<b>NRC FORM 680</b> (11-2002) NRCMD 10.159		<b>U.S. NUCLEAR REGULATORY COMMISSION</b>		<b>FOR PROCESSING USE ONLY</b>	
<b>DIFFERING PROFESSIONAL OPINION</b>				1. DPO CASE NUMBER	
<b>INSTRUCTIONS:</b> Prepare this form legibly and submit three copies to the address provided in Block 14 below.				2. DATE RECEIVED

3. NAME OF SUBMITTER Michael Peck		4. POSITION TITLE Senior Reactor Instructor		5. GRADE GG-14	
6. OFFICE/DIVISION/BRANCH/SECTION OCHCO/ADHRTD/RTTBB		7. BUILDING TTC	8. MAIL STOP	9. SUPERVISOR Steve Rutledge,

# Differing Professional Opinion – Diablo Canyon Seismic Issues

Figure 1, Comparison of the DDE/SSE and the HE Floor Response Spectrum, Containment Elevation 88'

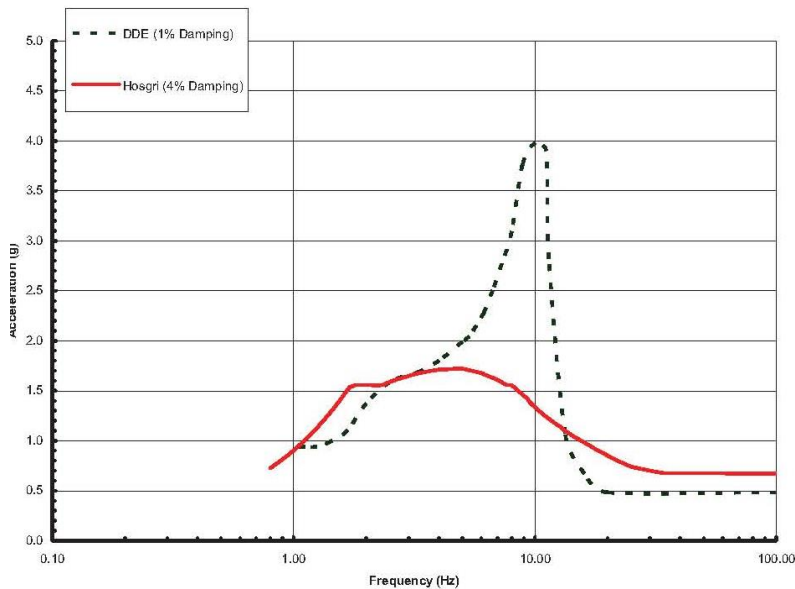
Figure 1 illustrates the results of the different methods and assumptions use in DDE/SSE safety analysis and the HE. This figure compares acceleration levels (shaking) in the reactor containment building.

Plant SSCs are most affected in the 3 to 8.5 Hz frequency range.

Note that the level of "shaking" is significantly greater for the SSE/DDE than for the HE at this plant location. This may seem counterintuitive since the HE is a much larger earthquake. However, as this figure illustrates, comparing ground motion alone is not sufficient to evaluate seismic qualification. Methods, assumptions, initial conditions, and acceptance criteria used in the analyses are just as important as ground motion.

The qualification process used information, such as shown in Figure 1, to establish the amount of seismic stress SSCs may be exposed to during the SSE. A component located at this location would be qualified for the SSE/DDE. If the SSC was also credited for HE safe shutdown, no additional qualification would be required. At this plant location, the seismic stress is dominated by the SSE/DDE. Qualification to the SSE/DDE would envelope the seismic stress generated by the HE.

**Figure 2**  
 HE Maximum CRDM Bending Moments<sup>17</sup>

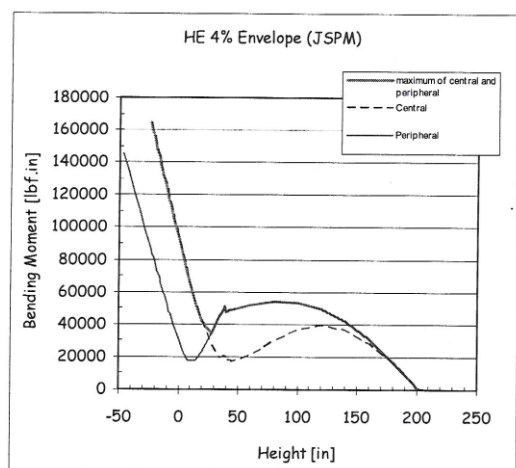
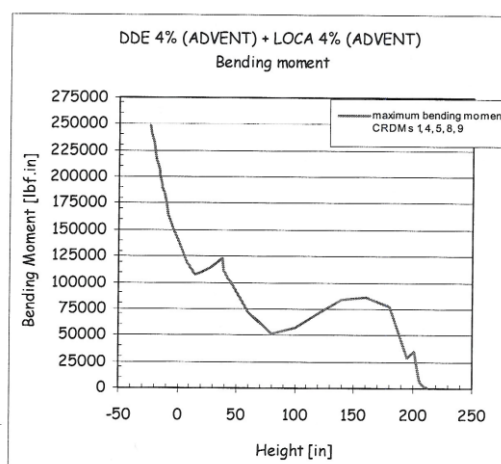
The Code methodology adds seismic loading, generated by either the SSE/DDE safety analysis or the HE, to other non-seismic loads affecting the component. The resulting SSE/DDE stress is significantly greater than for the HE in many loading cases. Again, this may sound counterintuitive since the HE is based on a much larger earthquake. These differences in component stress reflect the differences in the methods, assumptions, load combinations, and initial conditions used in each seismic analysis. For example, Figures 2 and 3 compare the Code bending moments calculated for the control rod drive mechanisms used to support the replacement reactor head modification. As seen in these figures, the bending moments (seismic stress) were much greater for SSE/DDE case than for the HE.

Figure 4  
Comparison of the DDE/SSE and the HE Floor  
Response Spectrum, Containment Elevation 88'

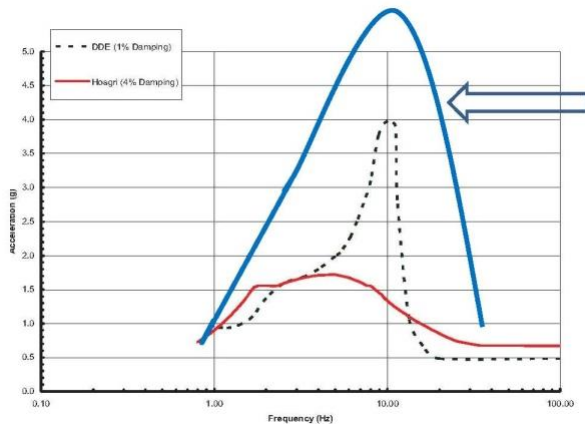
A comparison of the new seismic information against the existing SSE/DDE safety analysis would yield seismic stress greater than the values used during the original SSC qualification. However, in many cases, the actual SSC qualification tests were performed at higher levels than required to meet the design basis. These higher qualification levels provide engineering margin that may be recovered for “operability.”

Figure 5  
Relationship between Acceleration, Velocity as a Function of Damping<sup>57</sup>

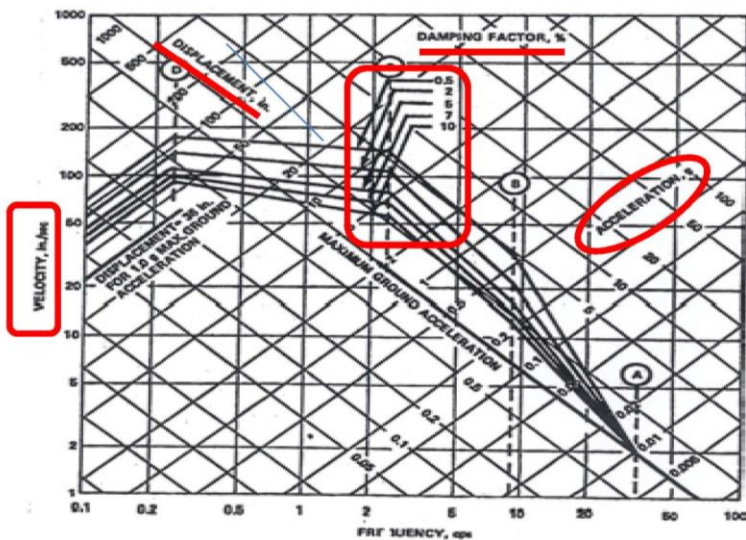
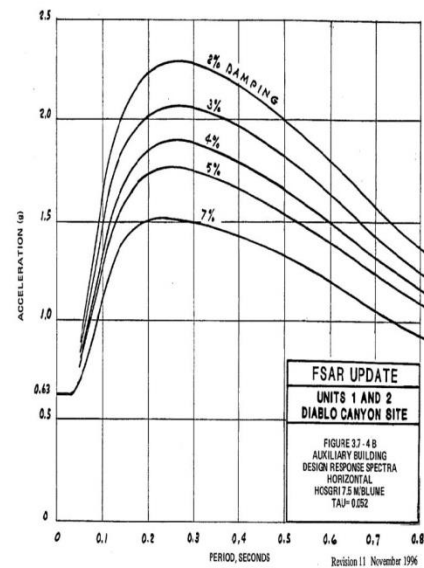
Higher damping values may be used for “operability,” provided that these values are appropriate to the application, as defined in the CLB. For example, the damping values specified for the SSE in Regulatory Guide 1.61, “Damping Values for Seismic Design of Nuclear Power Plants,<sup>58</sup>” may be used. Also, damping values higher than presented in Regulatory Guide 1.61, may also be used provided that they have been NRC approved for the specific application and material.
